VALUE ENGINEERING WORKSHOP REPORT

Project: SH21/Powers Boulevard & Research Parkway Interchange
Project No. STU 021A-004 (20913)

May 11, 2018

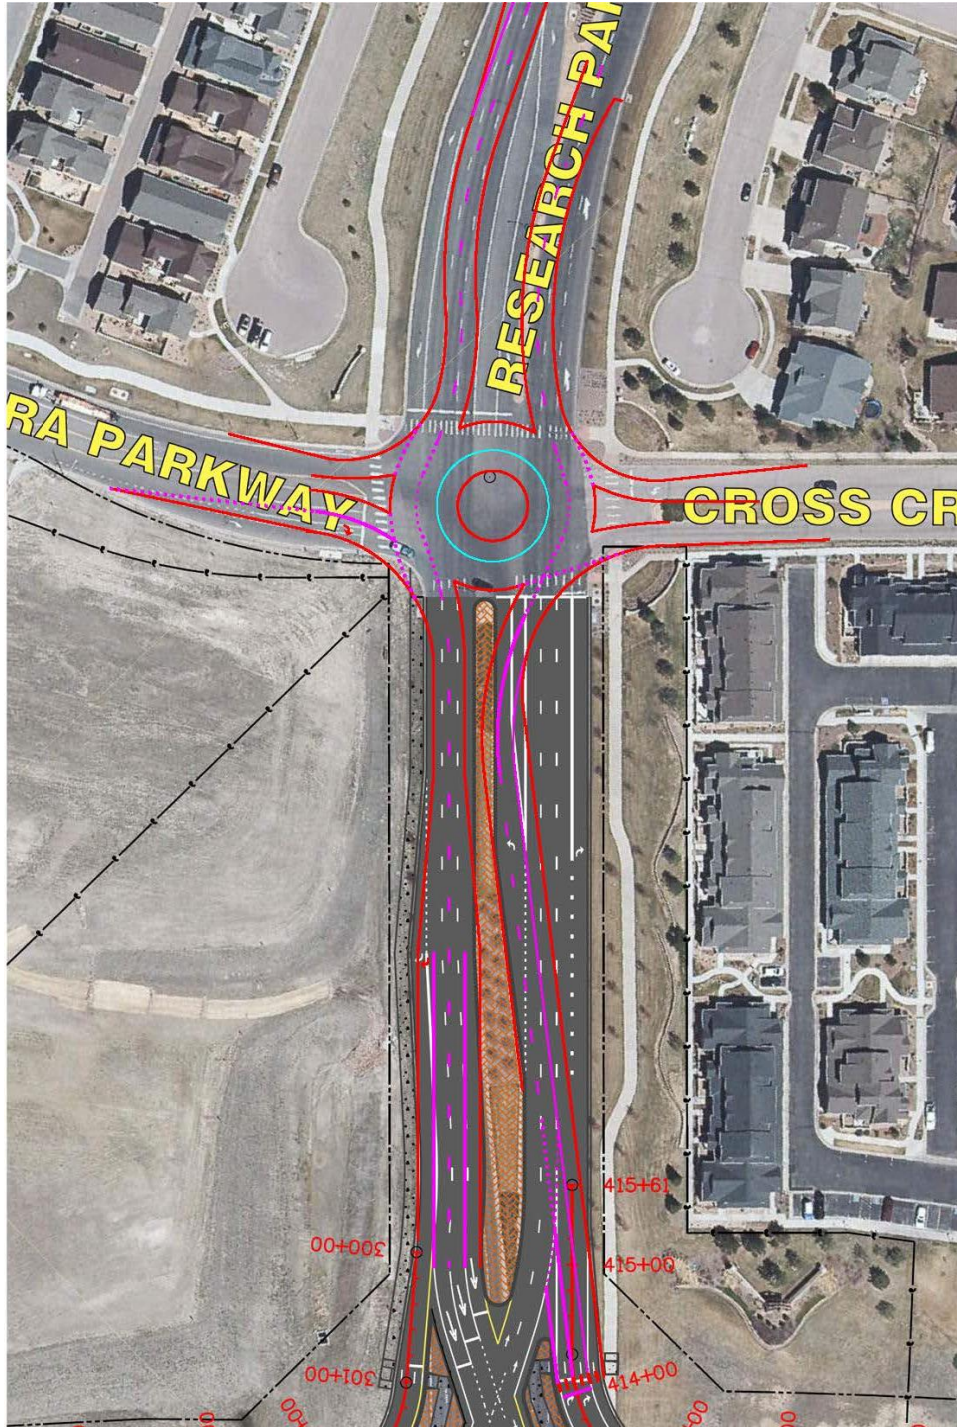
Eastbound Research Pkwy leaving the proposed DDI is composed of two thru lanes and two parallel, signalized right-turn added lanes. In order for right turn traffic to reach Grand Cordera Dr, three lane changes are made. In order for thru turn traffic to reach Cross Creek Dr, two lane changes are made. This appears to be problematic in the short 400-500 feet.

Westbound Research Pkwy entering the DDI is composed of three thru lanes with the left lane dropping for southbound Powers, (the #3 lane is developed west of Tutt Blvd). This configuration would require thru traffic to shift a lane to the right to stay balanced.

The roundabout option at Grand Cordera Pkwy/Cross Creek Dr would provide a 2040 solution to the intersection as well as limit weaving between intersections to one lane change.

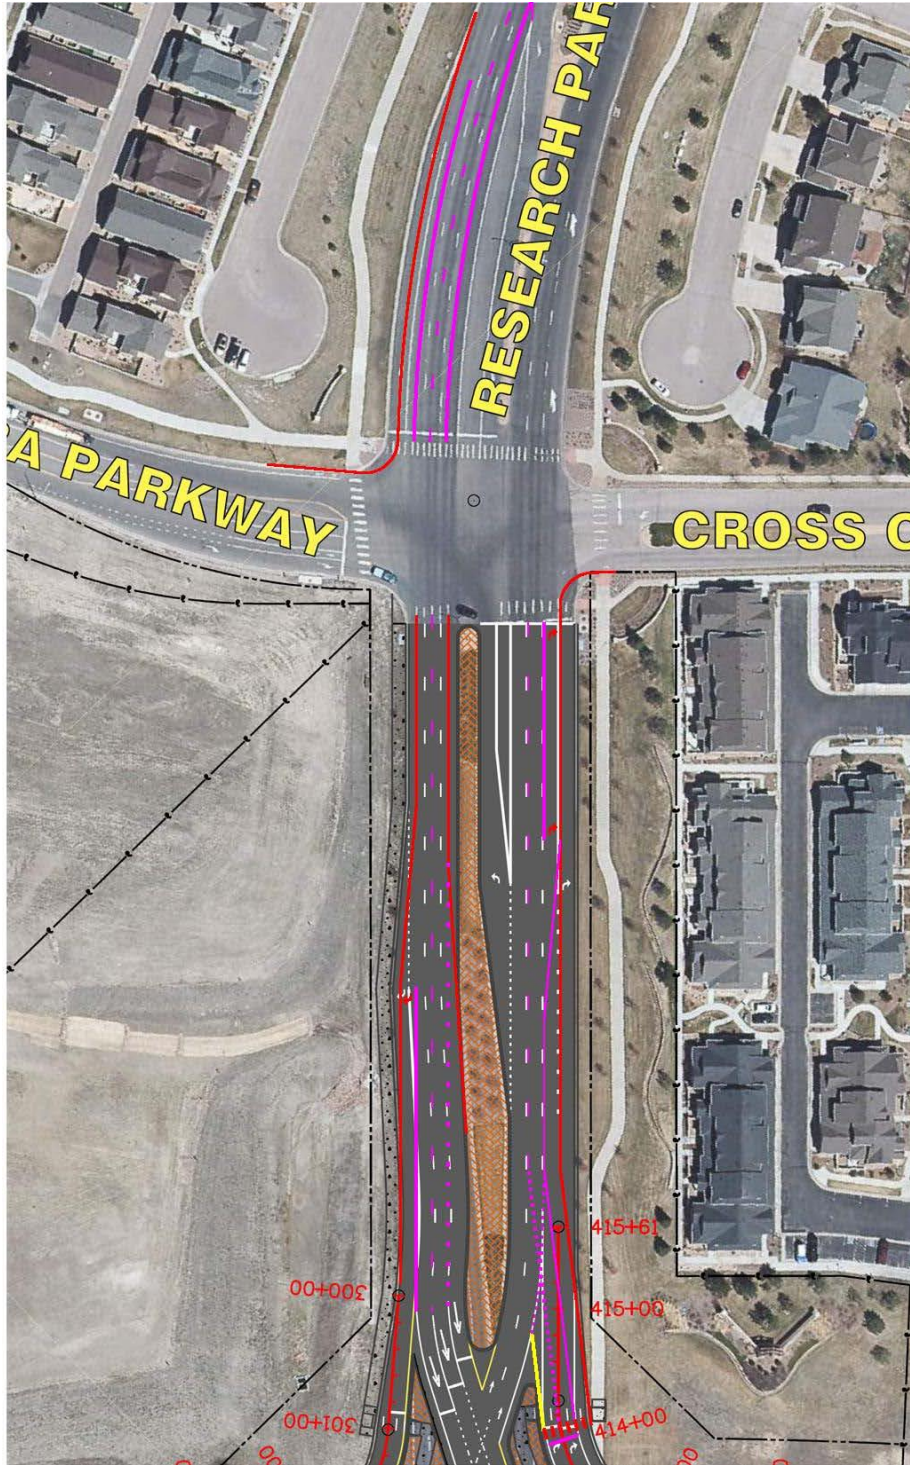
Eastbound Research Pkwy leaving the proposed DDI is composed of two thru lanes and two parallel, signalized right-turn added lanes. In order for right turn traffic to reach Grand Cordera Dr, three lane changes are made. In order for thru turn traffic to reach Cross Creek Dr, two lane changes are made. This appears to be problematic in the short 400-500 feet.

Westbound Research Pkwy entering the DDI is composed of three thru lanes with the left lane dropping for southbound Powers, (the #3 lane is developed west of Tutt Blvd). This configuration would require thru traffic to shift a lane to the right to stay balanced.

The signalized option at Grand Cordera Pkwy/Cross Creek Dr would provide a 2040 solution to the intersection. The narrowing of the intersection will limit weaving between intersections to one or two lane changes.

Current Intersection at Research Parkway – Channel Drive

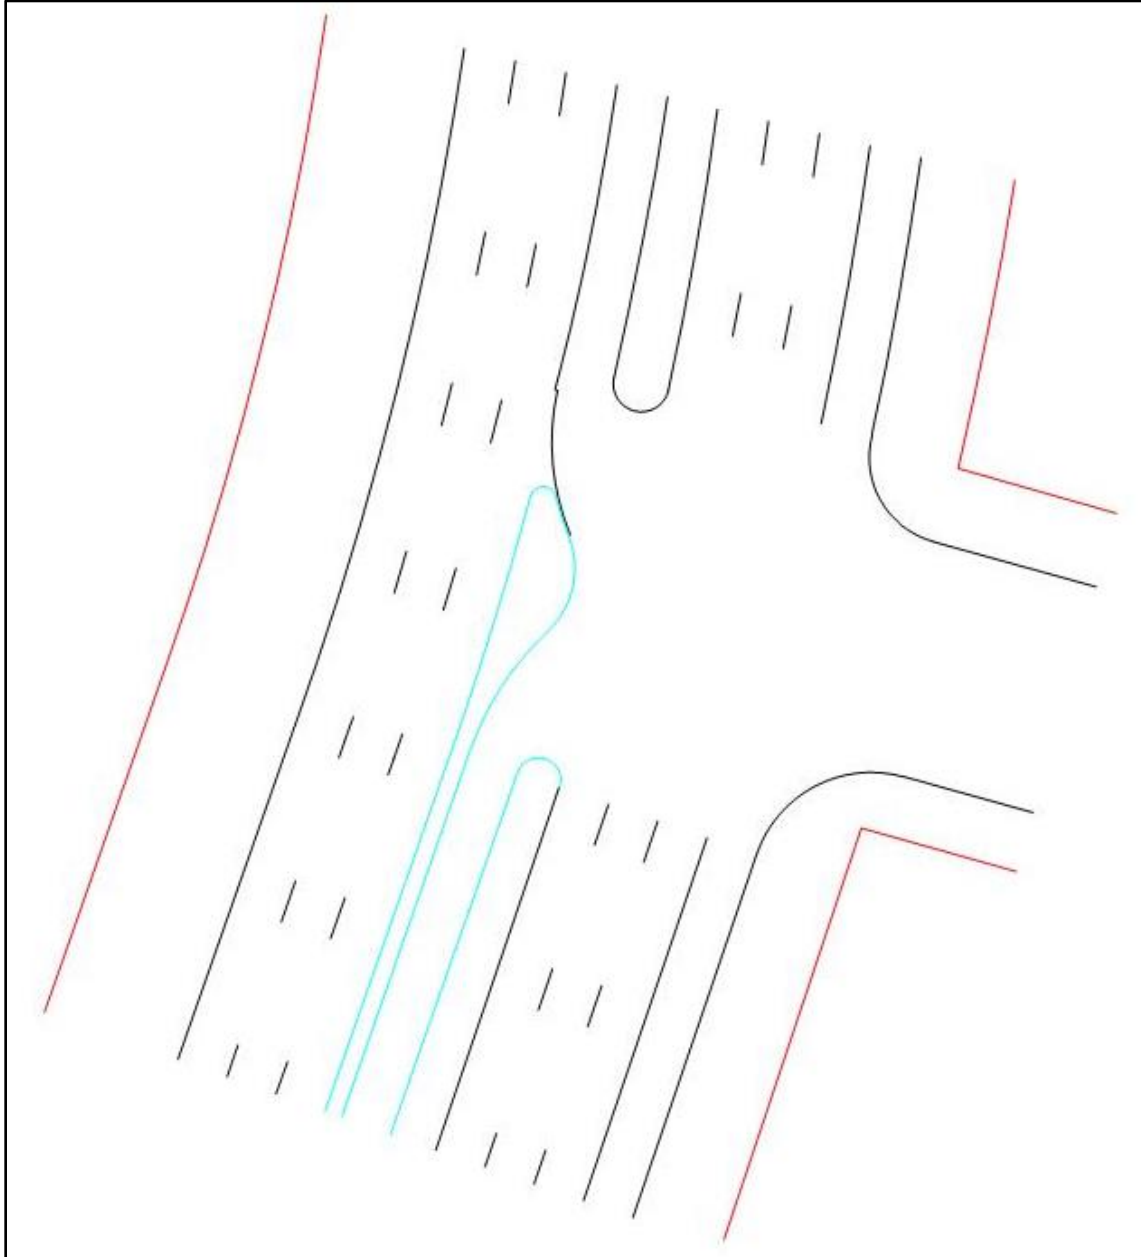
Proposed concept allows left turns out by making use of the median width to provide a channelized lane that can merge west of Channel Drive (continuous flow in through lanes eastbound on Research Parkway through intersection with Channel Drive).

- Accommodates an additional movement at Channel Drive intersection with Research Parkway.
- May provide additional pedestrian refuge on Research Parkway should a crossing be provided at this intersection.
- Reduces median area/cost on Channel Drive.
- May reduce median area/cost on Research Parkway (TBD).
- Does not require additional right-of-way along Research Parkway.

- Reduces pedestrian refuge area in median on Channel Drive.
- Requires additional surfacing on Research Parkway and Channel Drive to accommodate the left turn lane.
- May increase median area/cost on Research Parkway (TBD).
- May incur an additional traffic weave in westbound direction prior to intersection with Scarborough Drive.
- Eliminates median plantings.
